Subject: Remediation Progress Report and Groundwater Treatment Plan for One Hour
Martinizing, 285 East Hampton Avenue, Milwaukee, WI

FID: 241176650
BRRTS: 02-41-543260

OHM
285 E Hampton Ave.
Milwaukee, WI
FID: 241176650
BRRTS: 02-41-543260

Figure	10
Project	6194

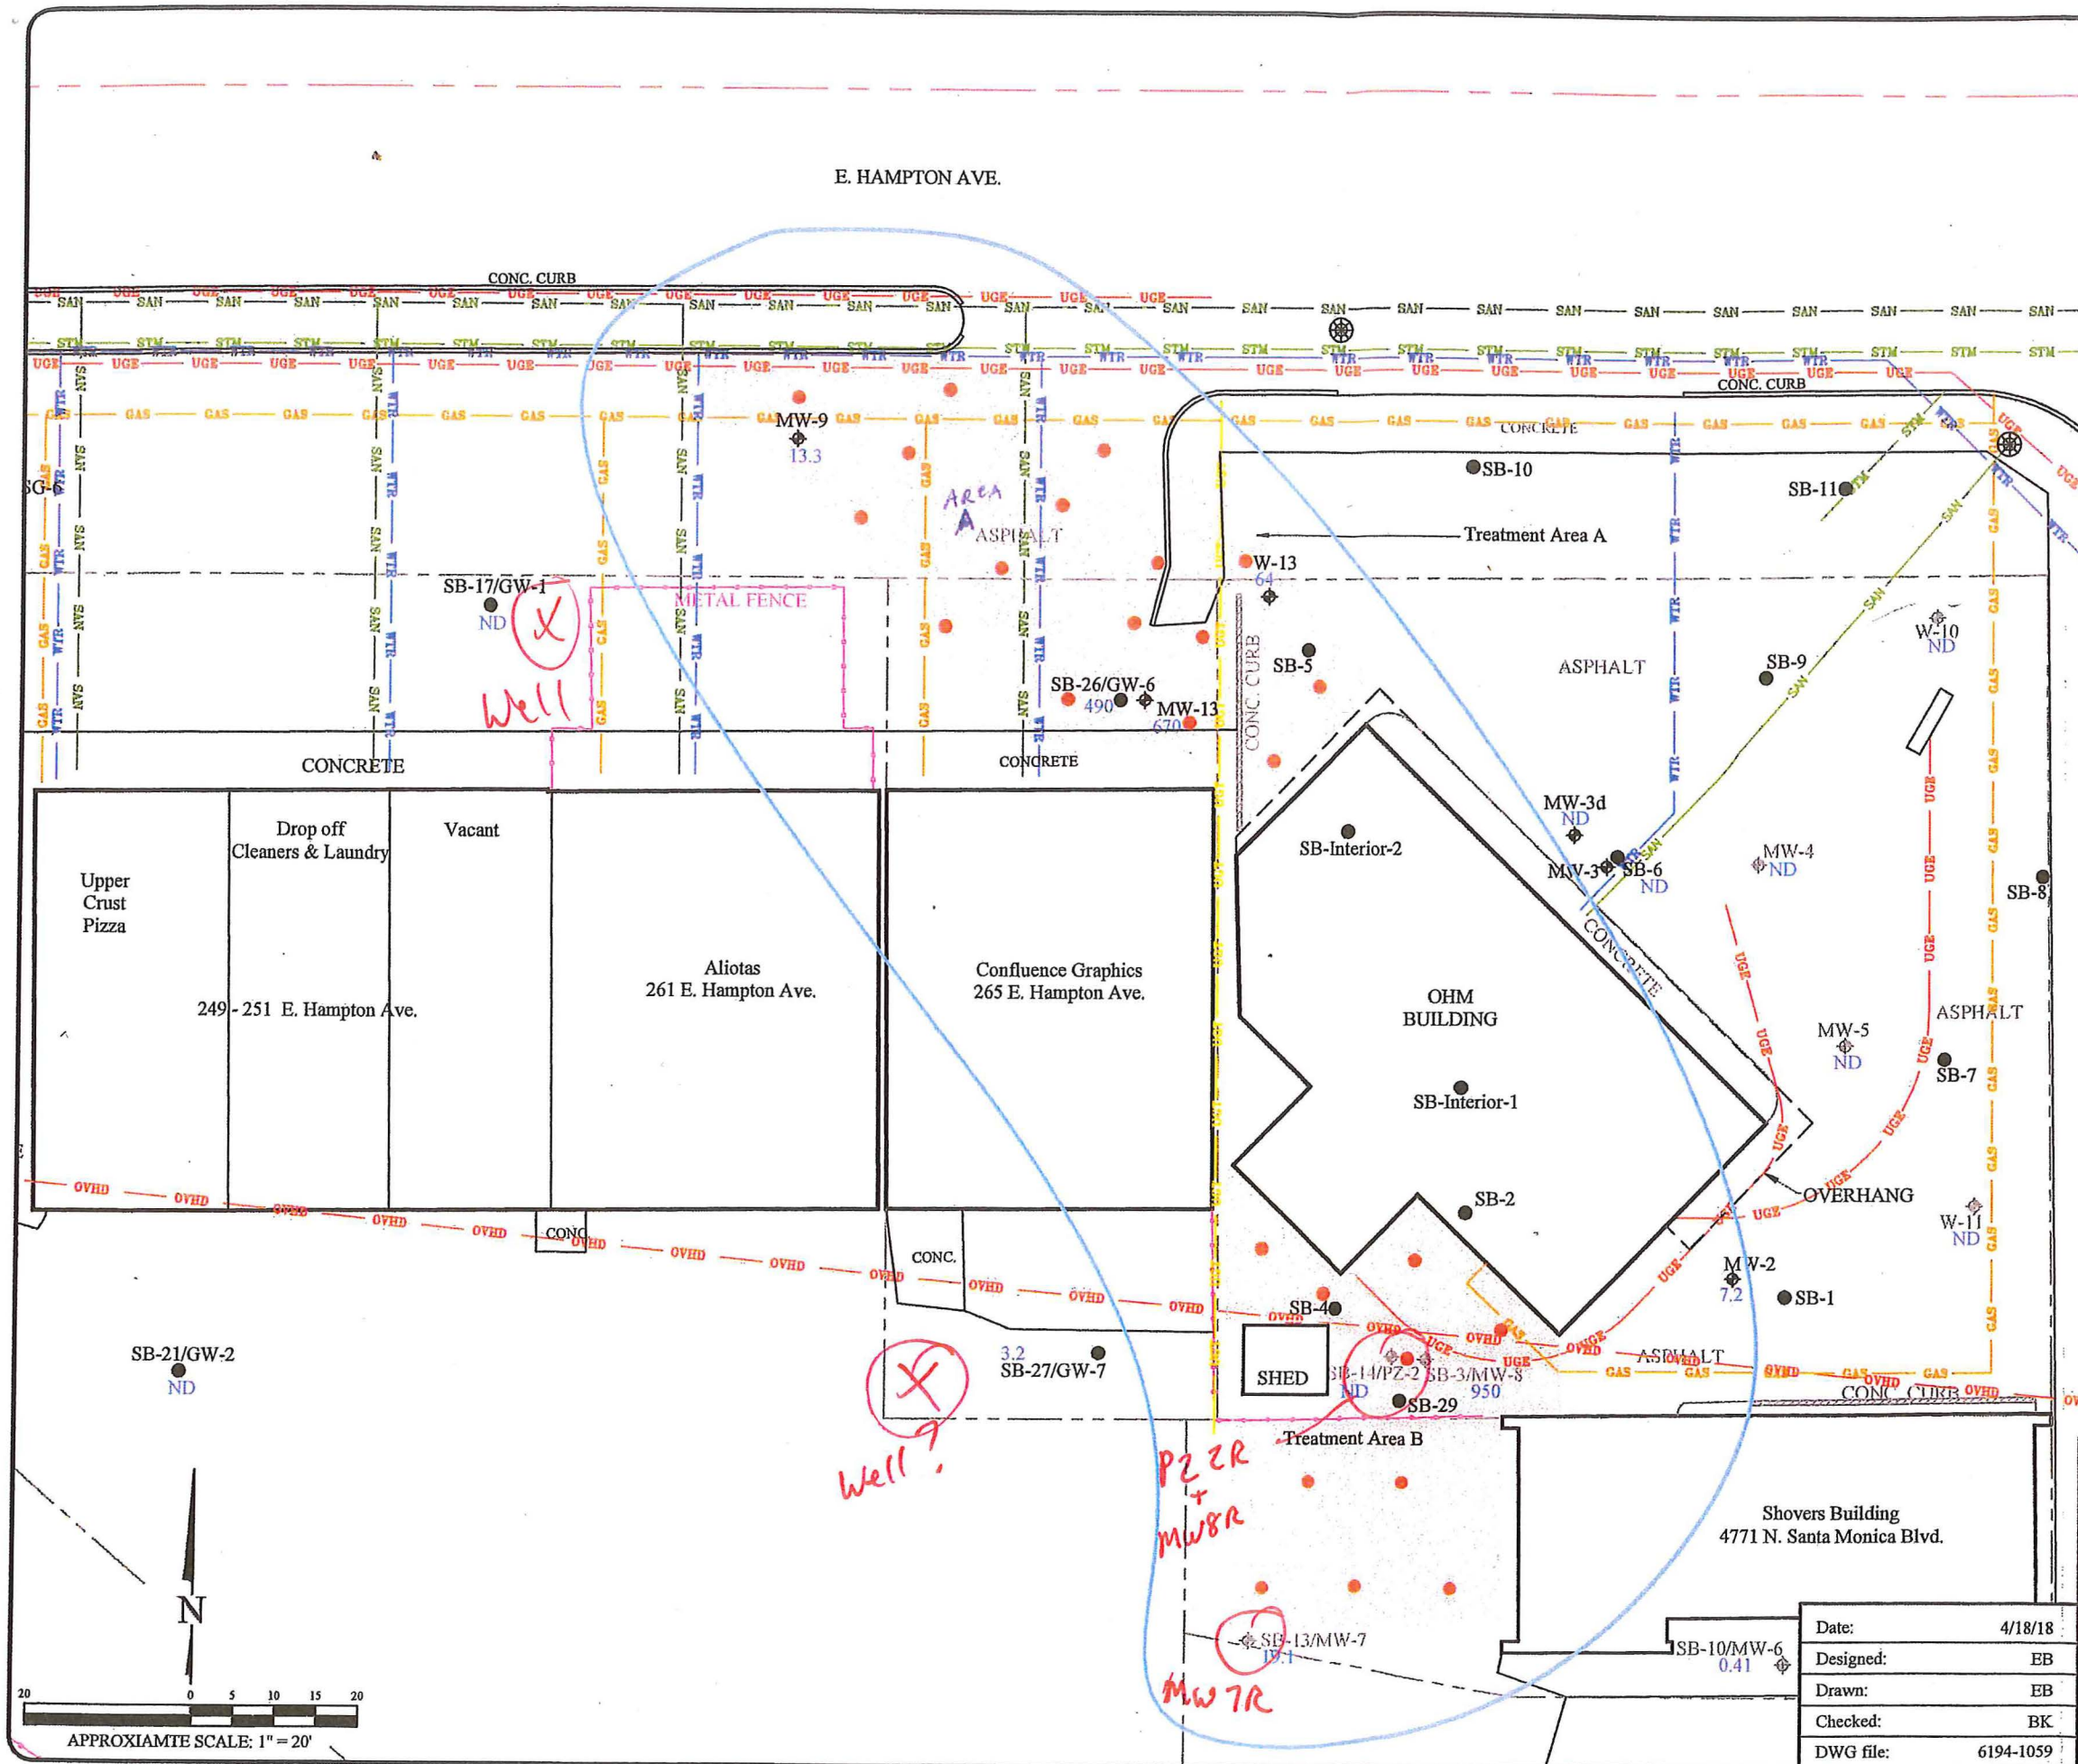
groundwater samples have not been collected since the soil source removal, the DNR suggests that you consider reinstalling groundwater monitoring wells MW-7R, MW-8R, and PZ-2R and sample all wells to determine what effect the excavation has on groundwater quality before you proceed with the proposed injection. Quarterly groundwater monitoring as proposed may indicate that natural attenuation alone is sufficiently remediating the groundwater. The DNR also recommends installation of additional groundwater monitoring wells near the former SB-17/GW-1 location and west of the shed near the former SB-27/GW-7 location to bound the degree and extent of the groundwater plume (see Figure 10).

5. Evaluate whether including injection points in the OHM building to reduce concentrations should be considered in the injection proposal.
6. According to the report, groundwater monitoring wells MW-7, MW-8, and PZ-2 were destroyed. Explain if and how these wells were abandoned.
